BFN TECHNICAL SPECIFICATIONS

DESCRIPTION AND JUSTIFICATION BROWNS FERRY NUCLEAR PLANT UNITS 1, 2, AND 3

Description of Change

Figure 6.2-1 Offsite Organization for Facility Management & Technical Support

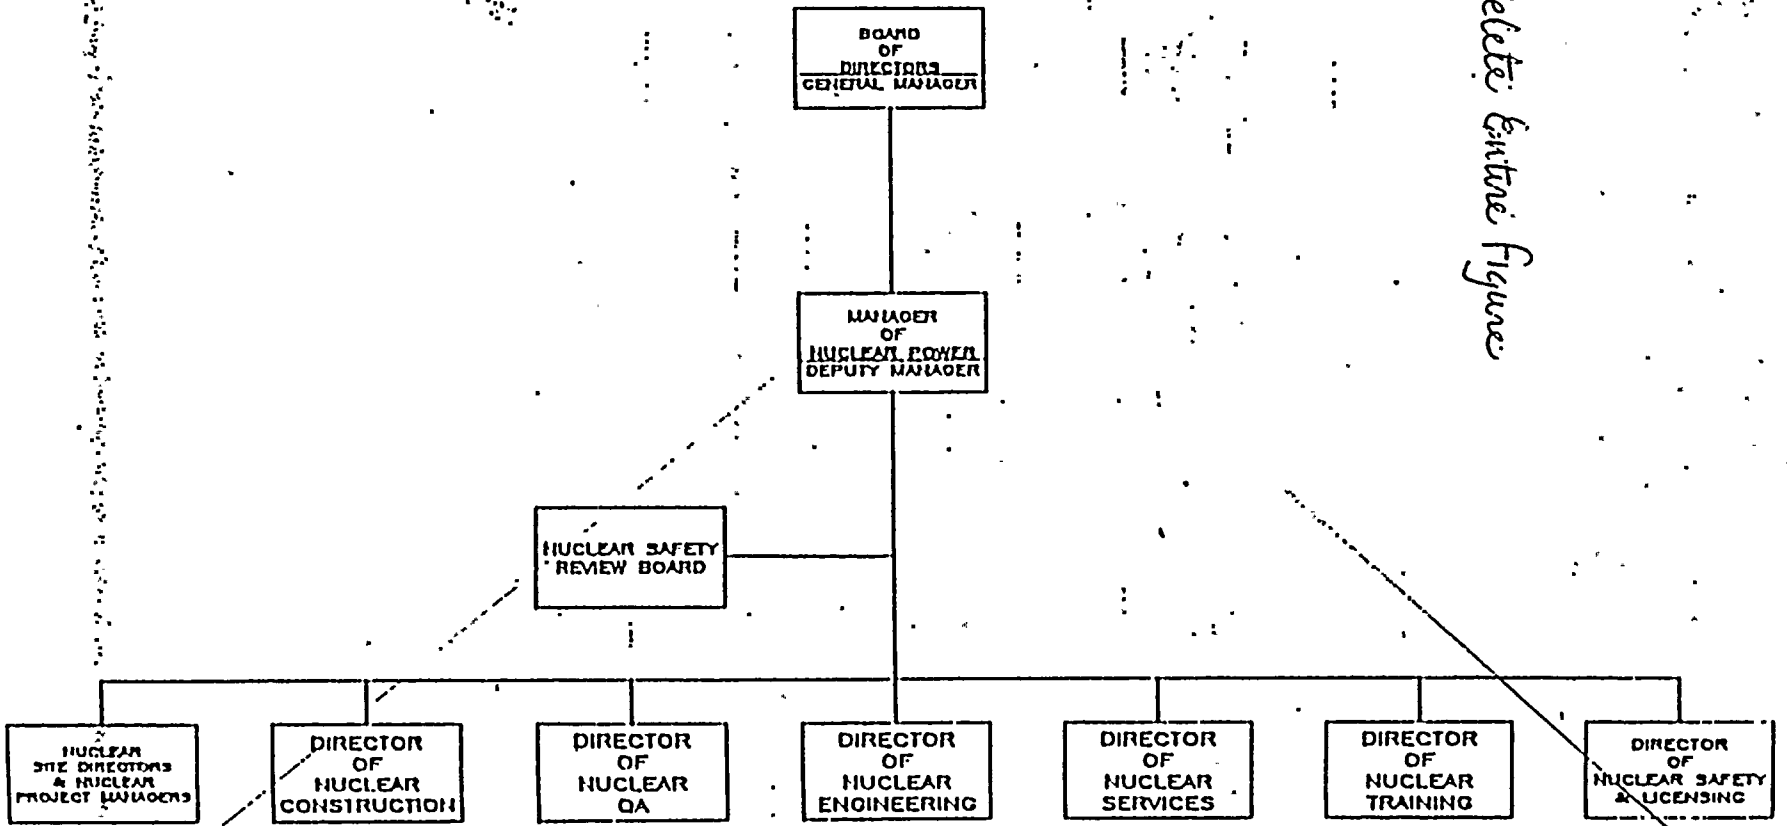
Delete Entire Figure

The deletion of the organizational charts (figures 6.2-1 and 6.2-2) and the addition of general organizational requirements is an administrative change to the BFN Technical Specifications. The NRC staff has determined that many of the details shown on the onsite and offsite organizational charts are not essential to the safe operation of the facility. NRC has provided guidance in Generic Letter 88-06 on the aspects of the organizational charts which are important to safety and are not covered under other specifications. These general requirements for organizational structure are being added to section 6.2.1, "Offsite and Onsite Organizations." This eliminates specific position titles from the requirements, thus eliminating the need for a license amendment to change a position title.
